UNITED STATES ENVIRONMENTAL PROTECTION AGENCY

Subject: EPA comments on the early release Draft Environmental Impact Statement (erDEIS)
for the Guam and CNMI Military Relocation, July 2009

**EPA Detailed Comments on Early Review Draft Environmental Impact Statement
(erDEIS) for the Guam and CNMI Military Relocation, July 2009**

Photo 1. Photograph of construction of Kilo Wharf, Apra Harbor Guam in June 2009. Elevated turbidity is visible inside and immediately outside the silt curtains on a day when no construction was underway.

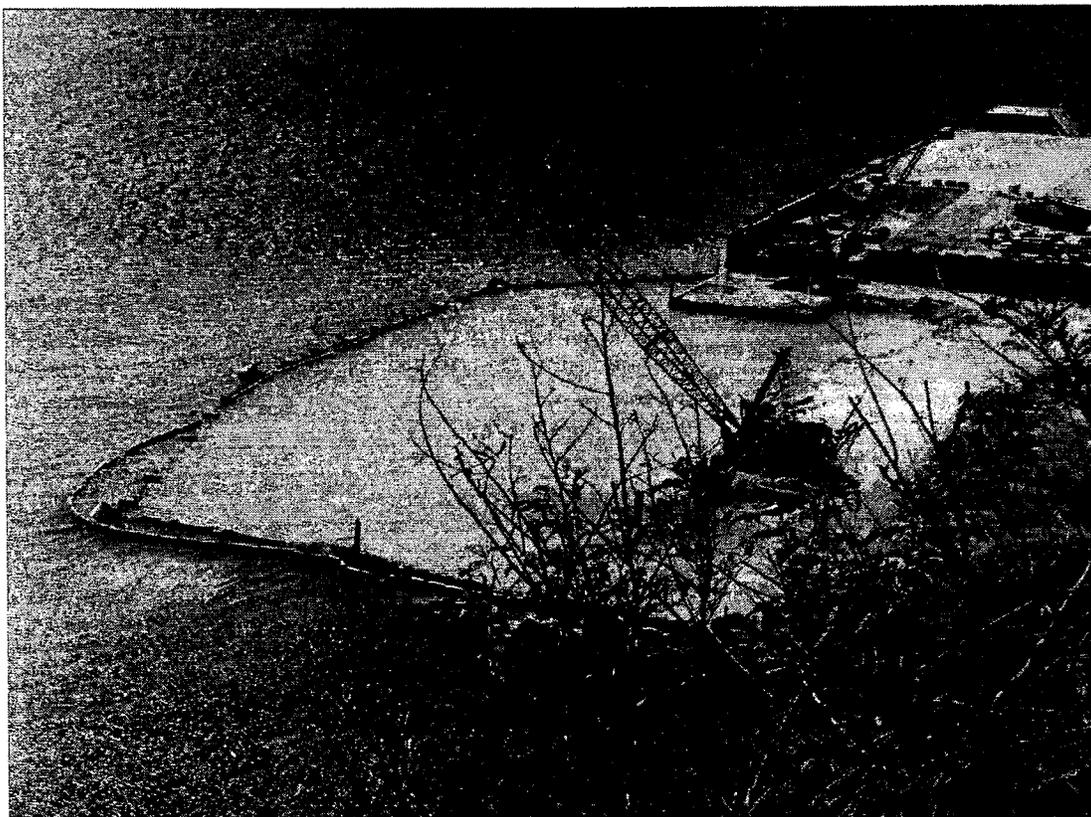
and outside of silt curtains at Kilo Wharf in the attached Photo 1 from June 2009 when dredging was not in operation. This observation contradicts the erDEIS assertion that elevated turbidity will dissipate rapidly with the cessation of dredging.

Recommendations: Provide an analysis of water quality impacts and compliance with water quality standards and toxic effluent standards for the CVN project. The DEIS should describe the best practical BMPs to prevent discharge of water and pollutants from land construction activities for moderate size rain events, exceeding the 2 year event. Dredge material dewatering sites should be sized to contain all water and runoff for moderate size rain events. Dredging activity should employ redundant layers of silt curtains, prohibit overflow from barges, and all other measures to avoid sediment plumes outside of the confined dredge area.
